## **ALCE PRO SUBDIVISION**

APPLICATION NUMBER 6 DATE March 6, 2014

REQUEST Subdivision

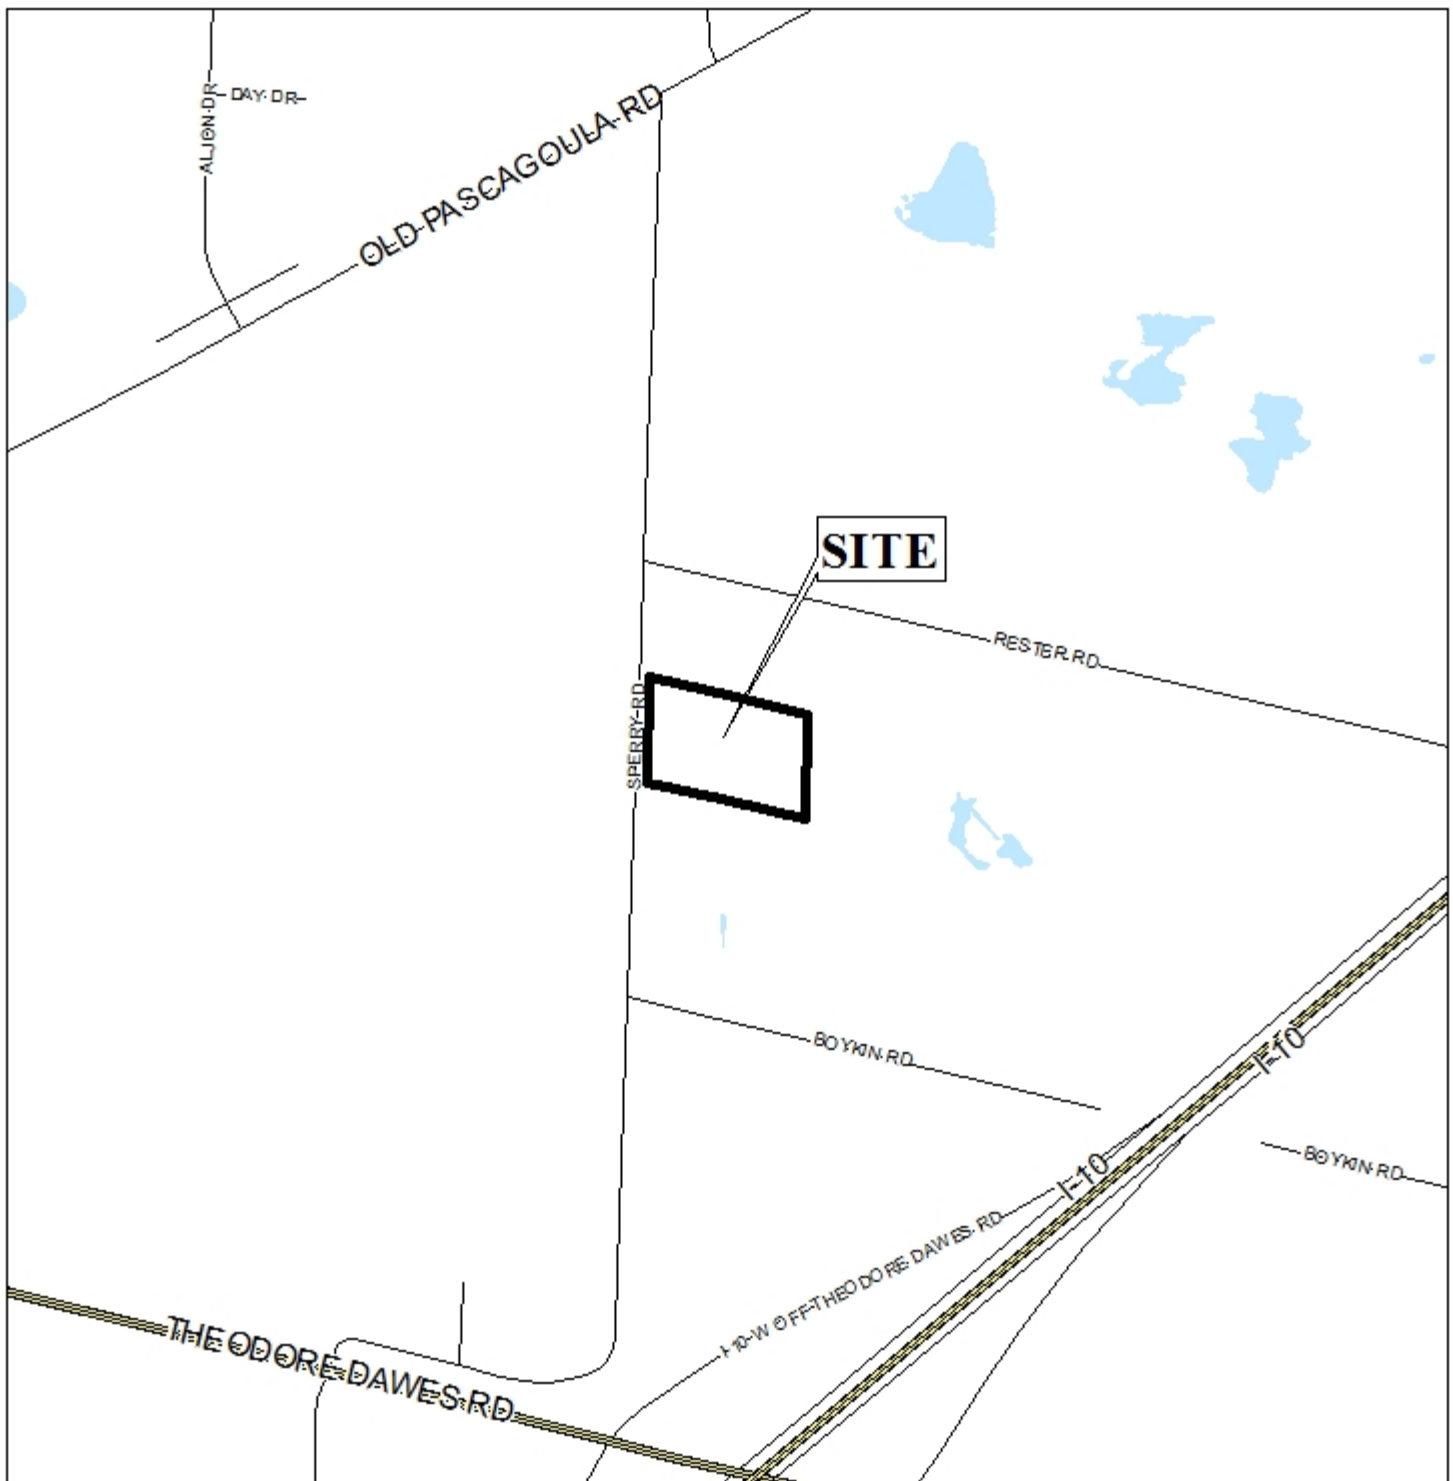
The proposed subdivision fronts Sperry Road, a minor street not provided with curb and gutter. The preliminary plat depicts a 60’ right-of way, thus no dedication is required.

As access management is a concern due to the proposed number of lots and the limited width of the property, Lots 1 and 2 should be limited to one shared curb-cut, Lots 3 and 4 should be limited to one shared curb-cut, and Lots 5 and 6 should be limited to one shared curb-cut to Sperry Road with the size, location and design of all curb-cuts to be approved by Mobile County Engineering and conform to AASHTO standards.

Section V.D.2. of the Subdivision Regulations states “lots for residential use shall be at least 60’ wide at the building setback line” and must be a minimum lot size of 7,200 square feet for lots served by public water and sanitary sewer. The preliminary plat depicts Lot 1 as being only 50’ wide, thus a waiver of Section V.D.2 would also be required, if approved.

The lot sizes are depicted in square feet and acres on the preliminary plat; and should be retained on the Final Plat, if approved.

The 25-foot minimum building setback line is also depicted on the preliminary plat and should be retained on the Final Plat, if approved.
